Re: ***Ex Parte Presentation:***
IB Docket No. 01-185;
Motient Services Inc. and Mobile Satellite Ventures Subsidiary LLC
File No. SAT-ASG-20010302-00017 et al.;
TMI Communications and Company, Limited Partnership
File No. SES-ASG-20010116-00099 et al.

Enclosed on behalf of Inmarsat Ventures plc is a paper entitled "Inmarsat Response to MSV *Ex Parte* of March 28 Concerning 'Monitoring and Control of Ancillary Terrestrial Emissions by MSV's Space Segment.'"

Inmarsat Response
to MSV *Ex Parte* of March 28
Concerning
“Monitoring and Control of
Ancillary Terrestrial Emissions
by MSV’s Space Segment”

Figure 1:

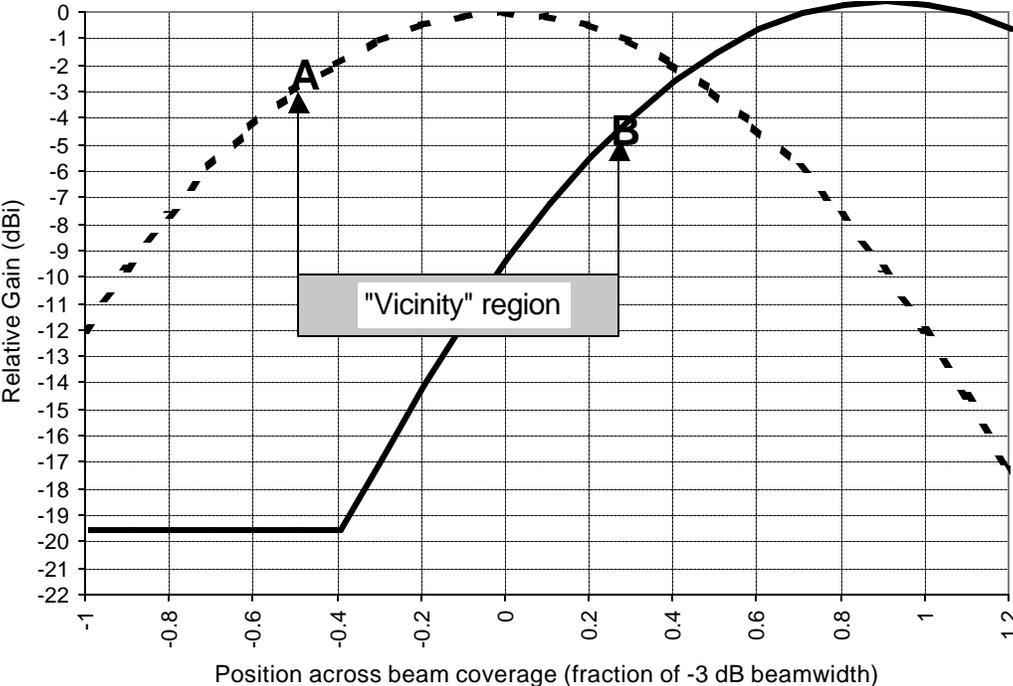
Figure 1 illustrates the gain profile of adjacent MSV satellite beams across a portion of the coverage area. The beam profile indicated by the dashed line is meant to represent one of the adjacent beams that is being used to monitor the ATC interference experienced by the beam whose profile is indicated by the solid line. The gain contours, which are Gaussian in roll-off, are made to cross over just below the -3 dB point, which is approximately the same as indicated by MSV for its proposed system. The plateau at -20 dB relative gain is merely an assumption. The cross-hatched rectangle is meant to indicate the “vicinity” region over which ATC transmissions will take place that are co-frequency with the intended MSV satellite transmissions in the central (solid) beam. Point “A” at the left end of this rectangle coincides with the -3 dB gain contour of the monitoring (dashed) beam. Point “B” at the right end of the rectangle is meant to indicate the outer extreme of the “white ring” exclusion zone that MSV has identified. The exact position of point “B”, in terms of the gain contour of the central (solid) beam, has not been accurately defined by MSV, but it is presumed to correspond with a central beam gain level significantly higher than -10 dB in order to achieve an “average” gain level of -10 dB across the

Compare the gain levels of the “monitoring” (dashed) beam and the “interfered-with” (solid) beam over the “vicinity” region. The former is from -3 dB to 0 dB relative gain. The latter is from somewhere in the region of -20 dB to somewhere significantly higher than -10 dB (in fact a value of -5 dB is shown in Figure 1 for illustrative purposes). The calibration of the proposed MSV monitoring system relies completely on the ATC interferers being distributed evenly across the “vicinity” region because of this difference in gain profile of the two adjacent beams over this region. If the ATC interferers are distributed non-uniformly then the monitoring results are meaningless. For example, if the majority of ATC interferers are concentrated towards the left end of the “vicinity” region then the monitoring (dashed) beam will over-estimate the interference received by the central (solid) beam. Conversely, if the ATC interferers are biased towards the right end of the “vicinity” region then the monitoring beam will under-estimate the interference received by the central beam.

Therefore, there is a fundamental problem here in the fact that the characteristics of the antenna being used to monitor the interference are very different from those of the antenna experiencing the interference, at least in the direction from which the interference originates. This creates huge uncertainty about the actual levels of interference being generated, and therefore means that the proposed monitoring solution is simply not feasible.
